# TECHNICAL BULLETIN

**MODEL/DERIVATIVE:**  
Range Rover

**Bulletin N°:** 0010  
**CDS. ref:** L8450bu  
**Issue:** 2  
**Date:** 06.10.99

### **INTERMITTENT OPERATION OF THE ATC SYSTEM - LINK HARNESS**

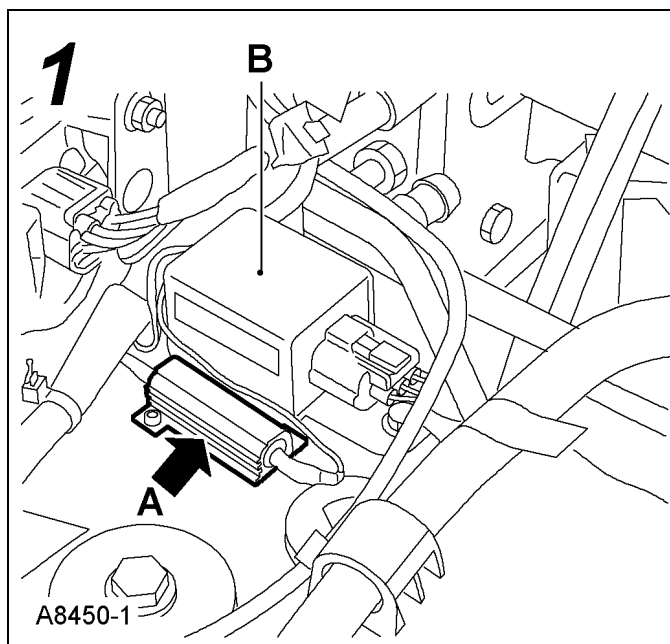
2. Position resistor (A in illustration 1) to the radiator side of the left hand front body mounting. Drill two 2.0mm holes and secure with self tapping screws from the kit. Secure the harness locally to support resistor wiring and maintain route.

**NOTE:** On earlier vehicles with dual crash sensors, the resistor will be positioned adjacent to the side of the crash sensor, (B in illustration 1). Later vehicles have one centrally located crash sensor but the position of the resistor remains the same.

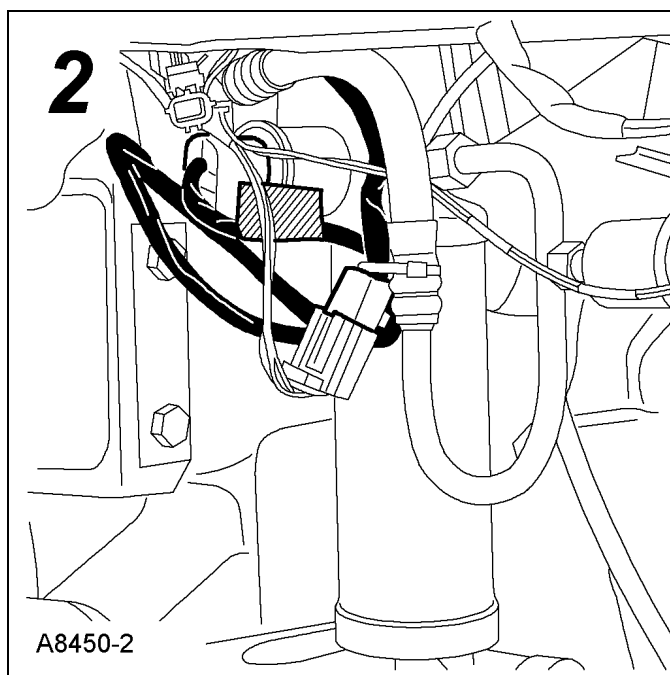
4. Disconnect the trinary pressure switch connector, connect the link harness to the switch and the original connector, (refer to illustration 2). The new harness is highlighted in black.

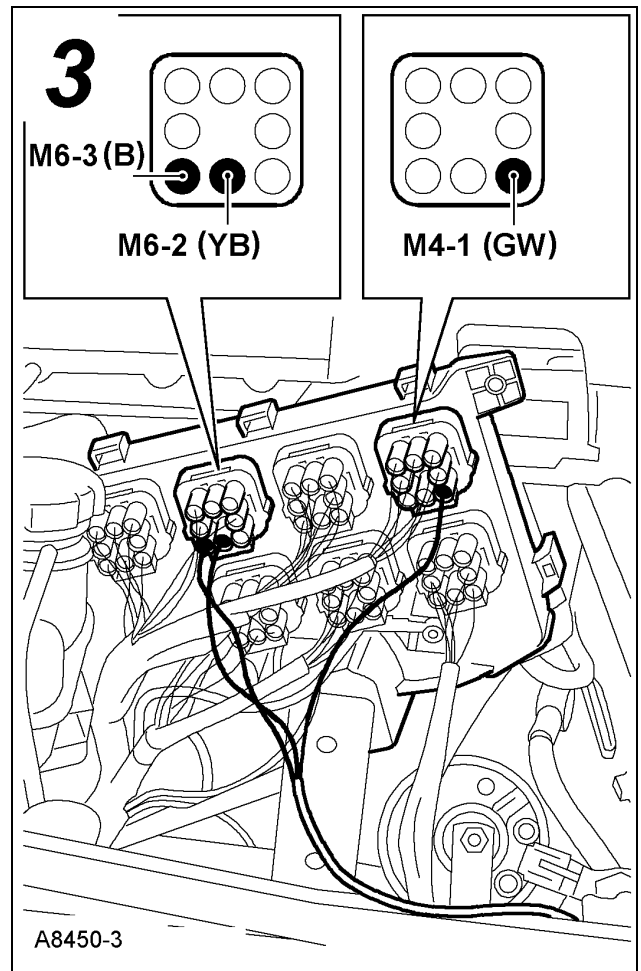
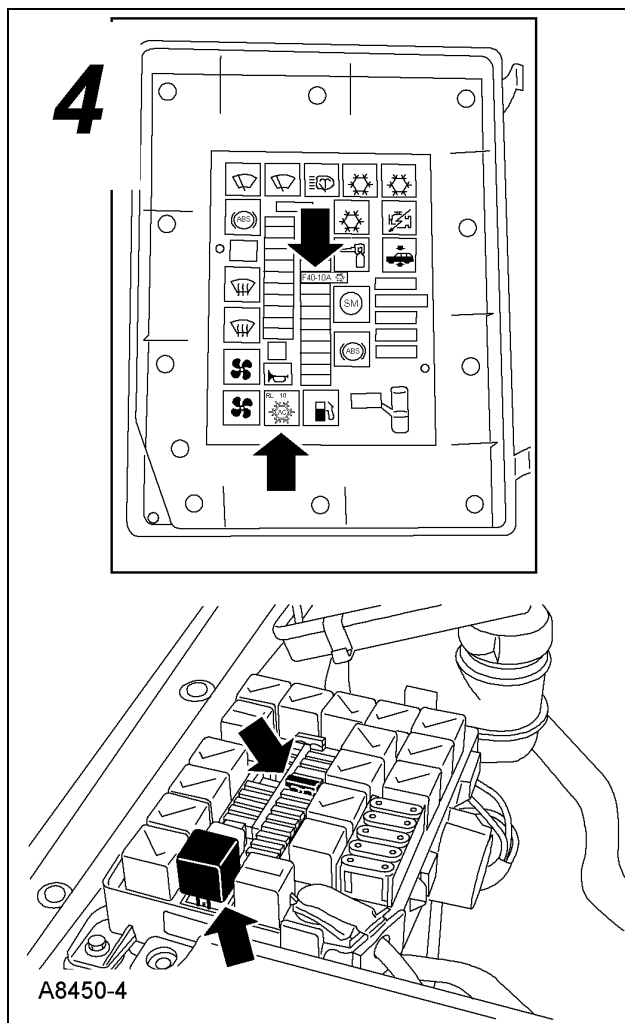
7. Fit link harness wires to fuse box connector locations as follows, (illustration 3 refers):

Violet block M6 - 3:  
Black wire (B)

Violet block M6 - 2:  
Yellow/Black wire (YB)

Blue block M4 - 1:  
Green/White wire (GW)

**Illustration 5 - Overall view of Link Harness Kit YMQ104590AA installation**

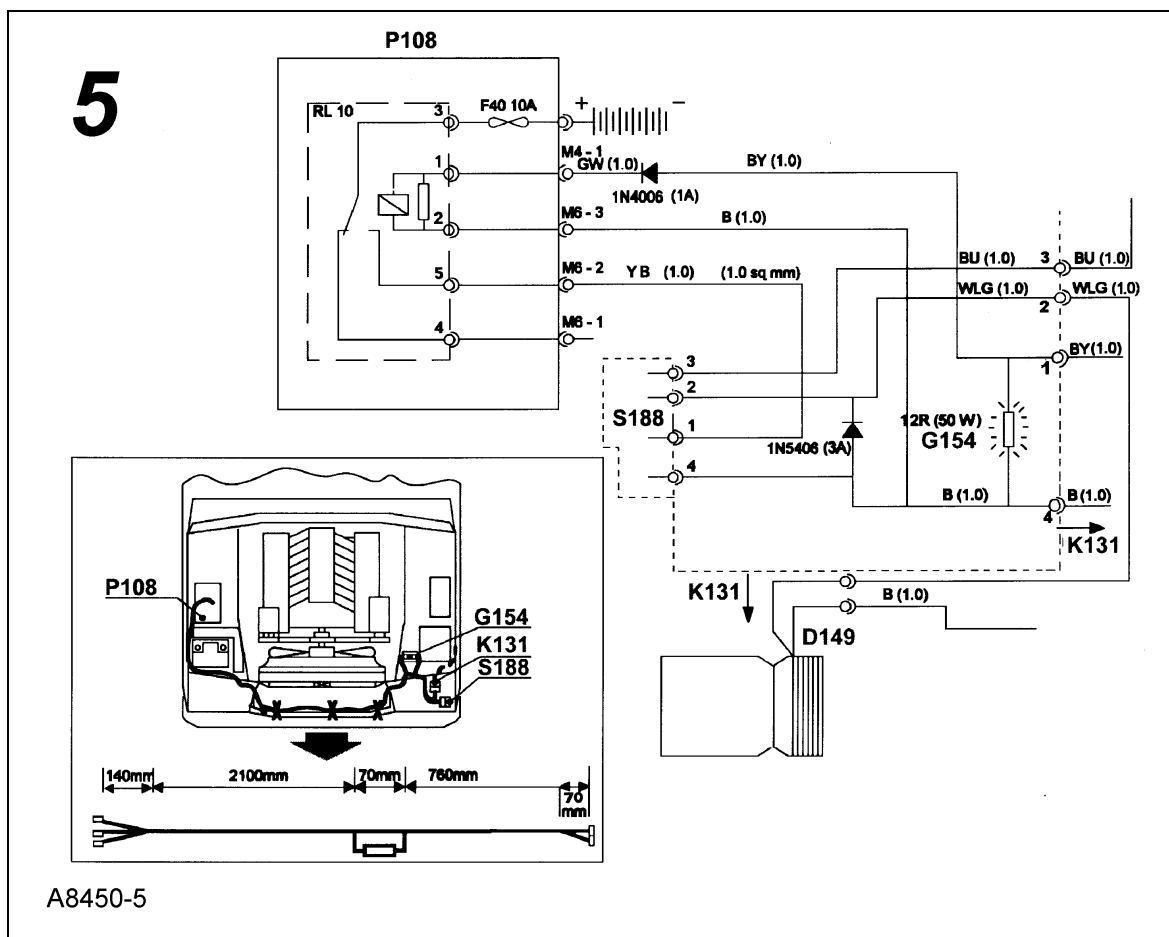
To ensure that sufficient voltage is available to enable full engagement of the compressor clutch, a modification is required to the compressor and alternator link harnesses. The purpose of this modification is to ensure that a minimum voltage of 11.5 volts is achieved at the compressor.

- For an overall view of the harness kit installation, refer to illustration 6.
  - Fit the harness kit as follows:
1. Remove the battery box cover and disconnect the battery, negative terminal first.

A8450-6

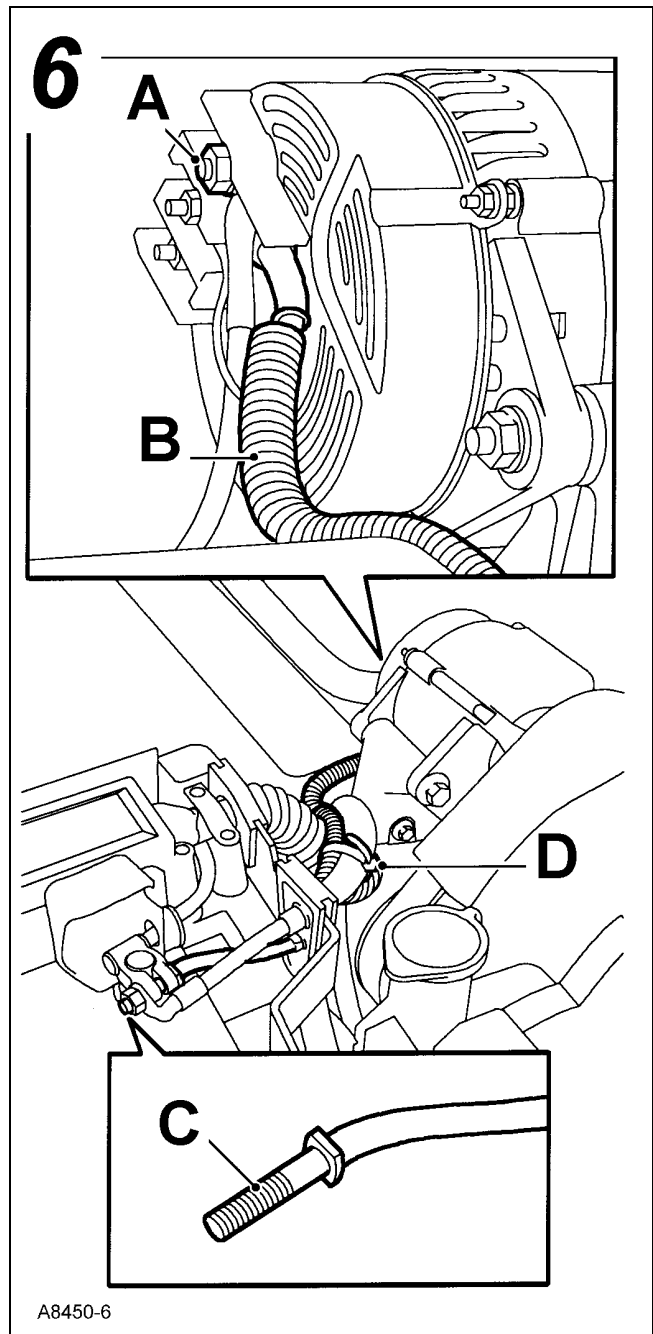
7. Remove the feed lead M8 nut from the B+ terminal of the alternator, (A in illustration 6).

8. Route the new lead (B in Illustration 6) from the battery box grommet, between the rocker cover and the alternator mounting bracket, to the alternator.

9. Connect the lead to the alternator B+ terminal and secure with the previously removed M8 nut, (A in illustration 6).

11. Reassemble the battery positive clamp, using the link lead stud (C in Illustration 6), in place of the discarded bolt and reconnect to the battery positive terminal.

12. Secure the additional lead to the existing harness by means of a cable tie, (D in illustration 6).

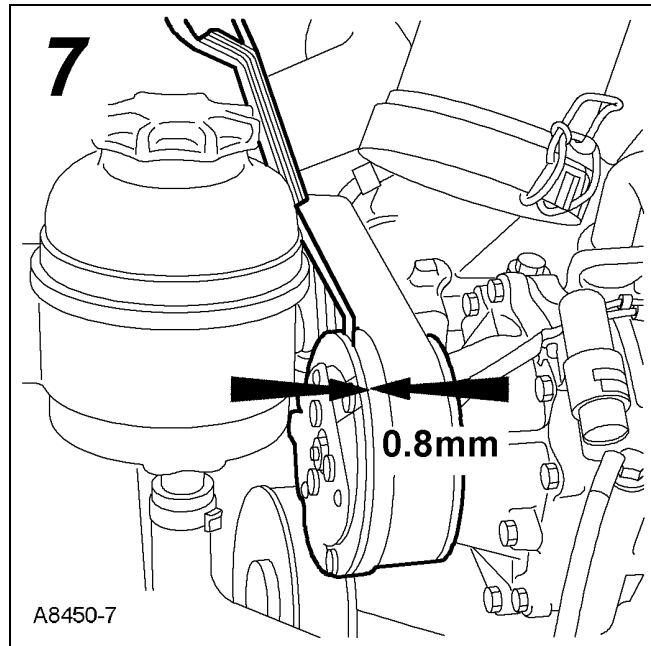
A clutch in serviceable condition will have an air gap not exceeding an average of 0.8mm when measured with a feeler gauge at three points around its circumference, (illustration 7 refers).

This dimension only applies to vehicles where the changes to ensure the 11.5 volts minimum supply have been installed.

If the average air gap exceeds 0.8mm, the compressor clutch must be replaced.
